Attention: Karen Harragon
Director
Social and other Infrastructure Assessments
Your Ref: SSD5560 MOD1; 10_0193; SSD 7628

Joint exhibition of three SSD applications: Moorebank Precinct West – response to submissions concept plan modification SSD 5506 – MOD 1; Moorebank Precinct East - concept plan modification MP 10_0193 MOD 2; and Moorebank Precinct East - stage 2 application SSD 7628.

In a letter to ABB dated 8 November 2016, SIMTA have indicated that the current drainage arrangements for the land to the east and south of the ABB site are shown in the following diagram:

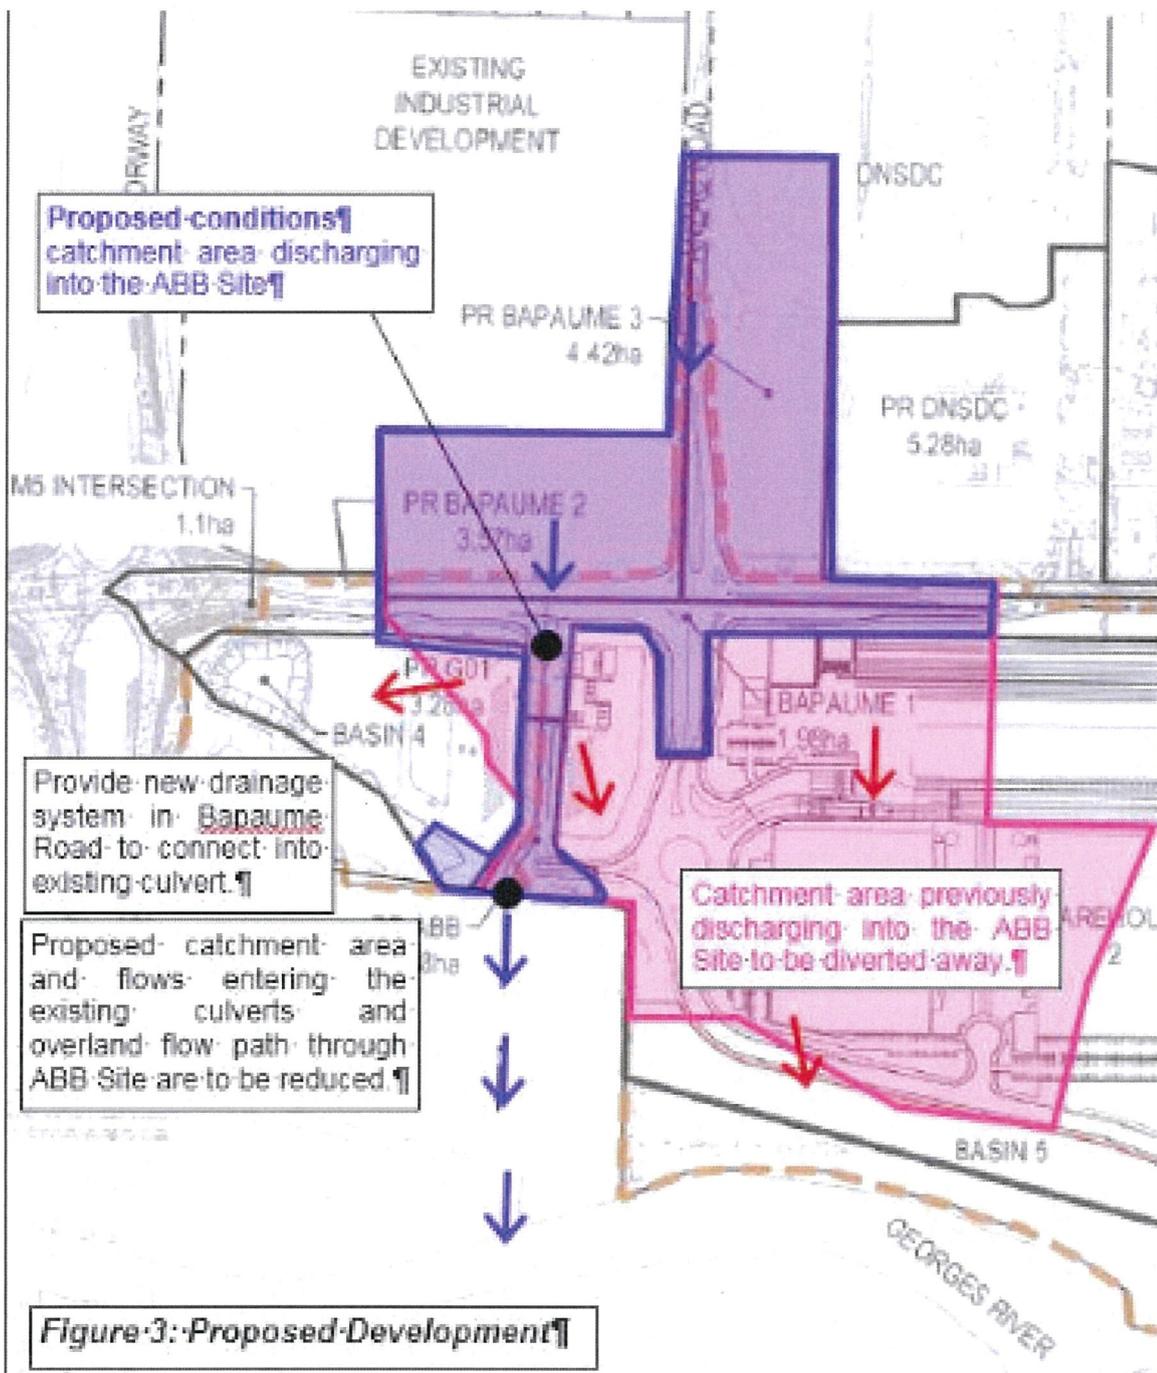
ABB has a number of concerns that it is discussing with SIMTA these include:

- The accuracy of the representation and modeling of the current scenarios;
- The lack of assessment of the construction phase impacts;
- The accuracy of the modeled outcomes.
- The management of first flush arrangements
- The use of and methods of construction of the proposed drains within the ABB site.

- What assessment has been conducted in respect of the existing drainage system (i.e the pipes and swale, within the ABB site to adequately convey the expected flows from the altered catchments to the east of the ABB site to the Georges River;

- What are the expected water levels in the OSD basin that are proposed in the NE corner of the catchment bounded by Bapaume Road, Moorebank Road, the M5 and the ABB Site;

- Is the existing pondage in the catchment to remain, and if so, what will be the expected water levels within the pondage;
- What is the nature of the subsoils in the abovementioned catchment;

- A new pipe drainage system is proposed along Bapaume Road to convey water from the altered catchments east of Moorebank Road to the ABB Site. What flows from the piped system will be designed to accommodate (i.e. 1:50 years, etc.) and how will excess flows be handled in more severe rain events?

- Not be issued until there is a complete assessment of the drainage arrangements and impacts for the construction phase and a validation of the drainage models for the both the construction and operational phases;

- Be subject to a condition that prior to commencement of works there be a drainage management plan that demonstrates to the satisfaction of the Minister that

- Adequate arrangements have been agreed with ABB to manage the construction and use of the proposed drainage infrastructure within the ABB Site both during construction and operation phases of the project;

- There is a documented legal right to use the ABB Site in the manner proposed during both construction and the operational phases of the Intermodal Project;

- Ensures that the outcomes set out in the [table above] are capable of being achieved and are achieved on an ongoing basis;
- Be subject to a condition that during the construction and operation of the Intermodal Project the drainage outcomes are consistent with or better than those specified [presently in the above table for the operational phase]

Areas of Known Soil Contamination (PCBs)

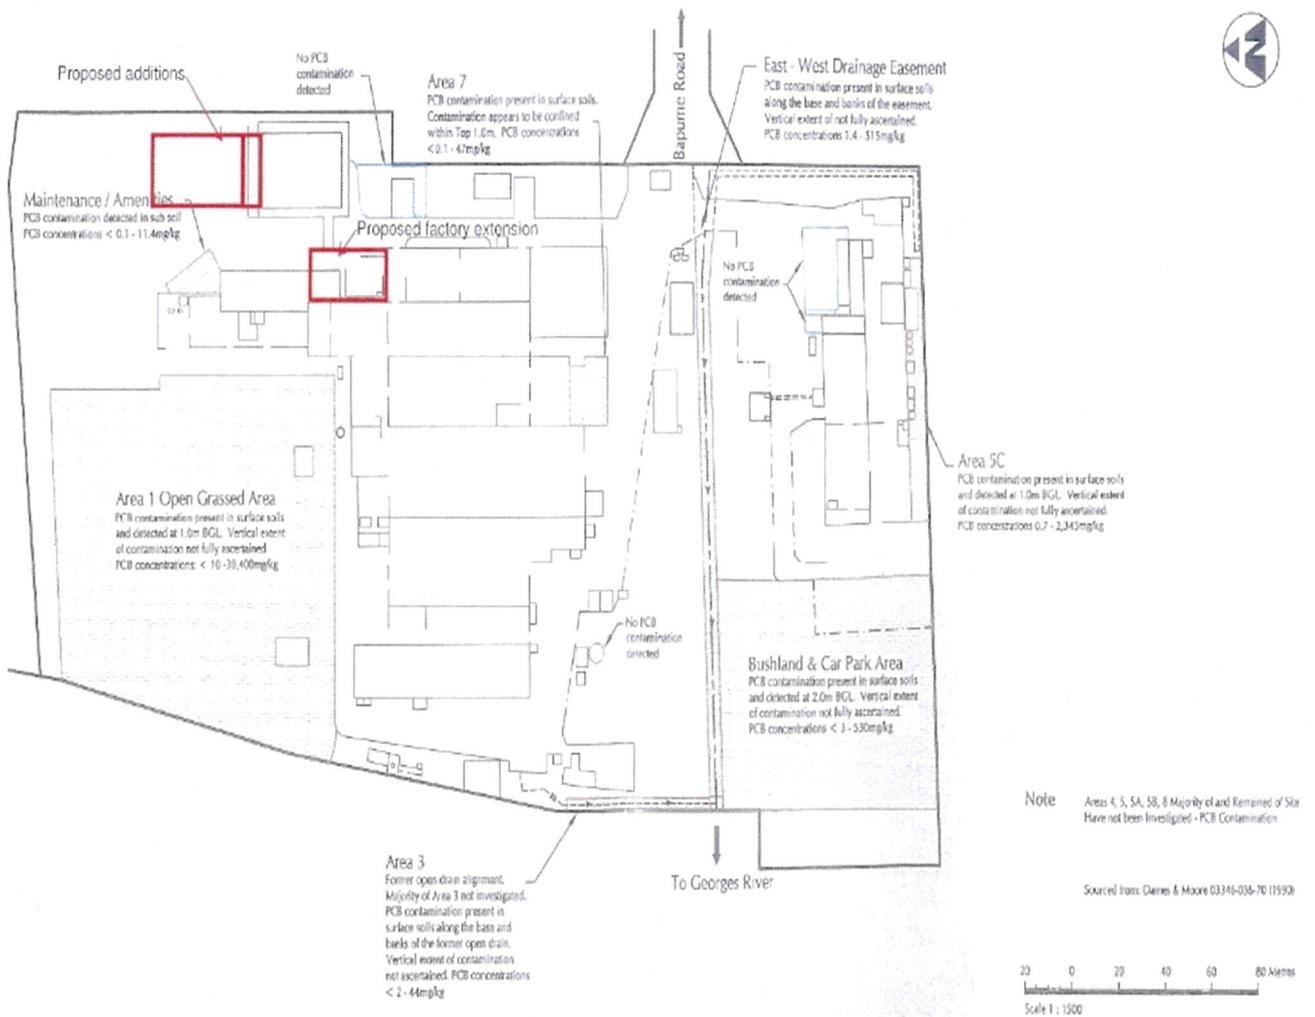
To date the assessment of drainage issues during both construction and operation phases of the Intermodal Project do not address the potential impacts of the Intermodal Project on the PCB contamination. ABB will work with SIMTA to provide necessary access and information to carry out that assessment. ABB is still endeavouring to understand the groundwater and surface water impacts and needs the following additional information:

- Provide justification, by drain model or similar, that both peak and base flow will not be increased in the drain. Please also confirm construction details for the drain which demonstrate that there will be no water infiltration into the ground or sediment migration in the backfill of the pipe;
- Confirm that no exacerbation will occur to increase the opportunity of overland flow compared to current conditions;
- Demonstrate that the proposed storm water retention basin will not increase the groundwater head at maximum height and long term duration of head compared to the existing conditions caused by the pond; and
- Demonstrate that the closest elevated earth works will not cause consolidation sediments which could adversely impact the underlying aquifer resulting in alteration in standing water level, groundwater velocity and direction.

- Not be granted until there is an assessment of these matters for both the construction and operation phases;
- Be subject to a condition that requires that:

- Prior to commencement of construction works in the vicinity of the ABB Site the proponent demonstrate to the satisfaction of the EPA that the proposed works and arrangements will not cause the PCB contamination to move or to flow to the council land to the west of the ABB Site or to the Georges river and will not exacerbate the risks to people or the environment from the PCB contamination;

- Monitoring equipment be installed to enable the groundwater to be monitored to demonstrate that the project works have not impacted on the PCB contaminated groundwater;

- If the works do impact the PCB contaminated groundwater that the proponent take steps to manage and mitigate that impact – including preventing the contamination moving to the Georges River.

SIMTA has provided information in respect of traffic movements including construction of a new access road and round about to the south of Bapaume road as seen on in the following diagram:

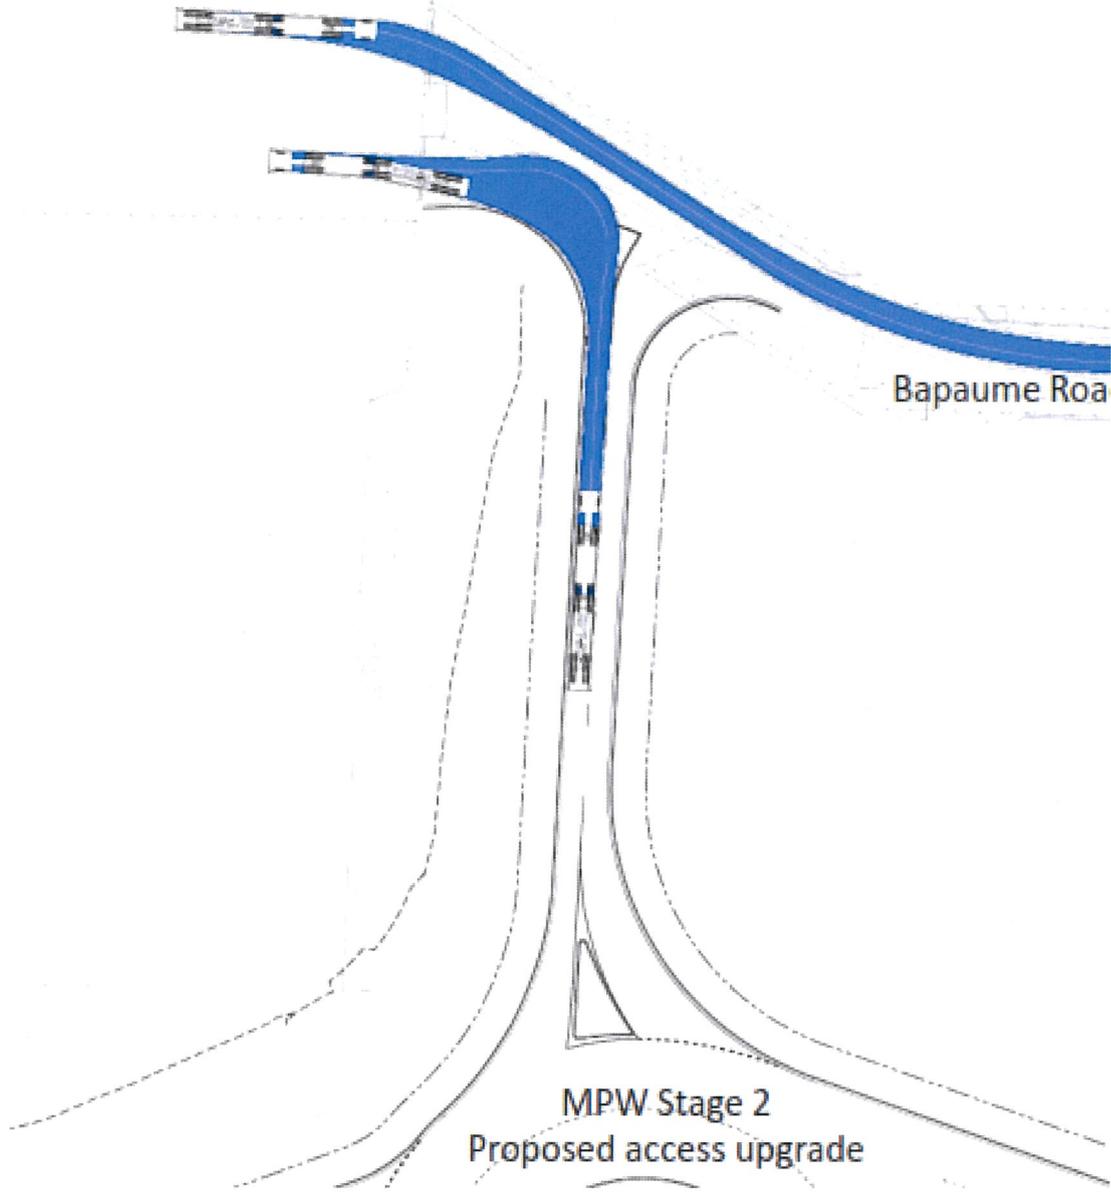
The proposed signalisation of Moorebank Avenue and Anzac Road is reliant on raised median being constructed upstream across Bapaume Road. This will result in the Bapaume Road intersection operating with a left-in and left-out arrangement.

Further information is therefore required to understand the specific effects on journeys originating to the ABB site from the north (including the M5 Motorway) and journeys destined to Moorebank Avenue, south of Anzac Road. Modelling outputs are requested for the following intersections:

- Intersection of Moorebank Avenue and Anzac Road,
- Internal roundabout intersection, and
- Intersection of Moorebank Avenue and Bapaume Road.

In addition to the overall Level of Service achieved for these intersections, the performance of each individual approach (delays and queue lengths) need to be made available in order to establish the additional journey times that ABB users will be subjected to over existing conditions. As a substantial proportion of SIMTRA traffic will comprise of heavy vehicles, it should be confirmed whether heavy vehicle percentages have been accounted for in the software modelling undertaken.

- Confirmation of the maximum daily number of heavy vehicle traffic movements for the above three intersections, during both construction and operational phases.
- A schedule showing a breakdown of truck movements each hour. This should also include details of any organised 'platoon' of trucks departing the site.
- Routes for all SIMTA trucks accessing the arterial road network.
- Swept path analysis demonstrating all permissible movements at the above three intersections for the largest design vehicle (SIMTA or ABB).

We consider that Anzac Road should be the primary access for SIMTA and therefore we expect no development traffic to enter Bapaume Road. In this regard, mitigation measures will need to be outlined as to preventing/discouraging non-ABB traffic to access this road via the northern leg of the SIMTA roundabout. It should be noted that as right turns into/from Bapaume Road will be prohibited, these proposed measures should not impact on ABB trucks accessing the site via the roundabout.

Finally, the impacts of these truck movements on pedestrians should be examined. Pedestrians currently use Bapaume Road to enter the ABB site, and are accustomed to low traffic volumes. Notwithstanding providing details on all proposed pedestrian footpath/crossing treatments, sight distance assessments should be undertaken in accordance with relevant guidelines to ensure adequate visibility between trucks and pedestrians at all intersections and SIMTA site accesses. Road Safety Audits should be conducted to the satisfaction of Council or Roads and Maritime Services, if warranted.
